NEW YORK STATE | Department of Environmental Conservation

May 27, 2026

Re: 100% Remedial Design Report
G.T.E. Products Corporation Site
Site No.: 850003
Town of Seneca Falls, Seneca (C)

FIGURE 3

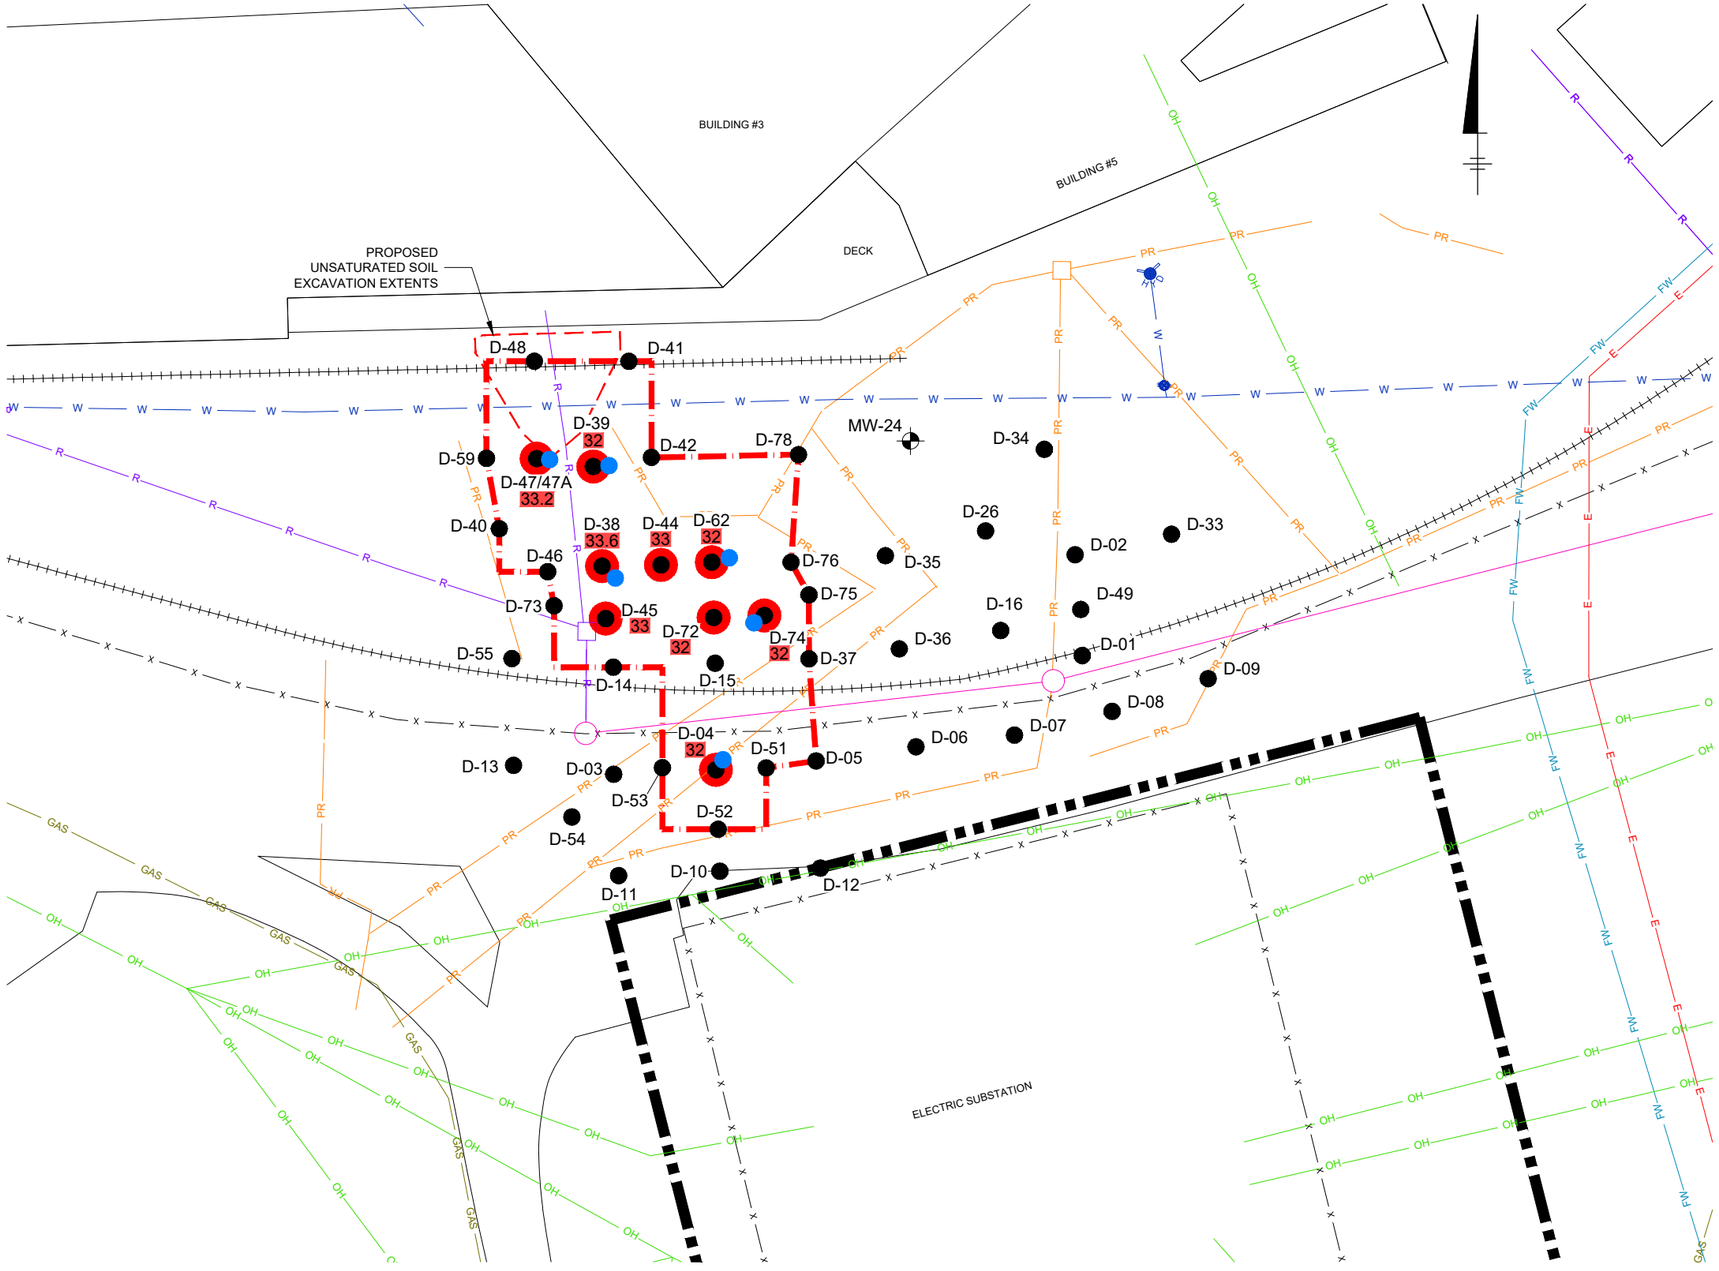
68. Figure 3: NYSDEC understands that the above grade SSDS piping will not be impacted during the ISTR heating activities.
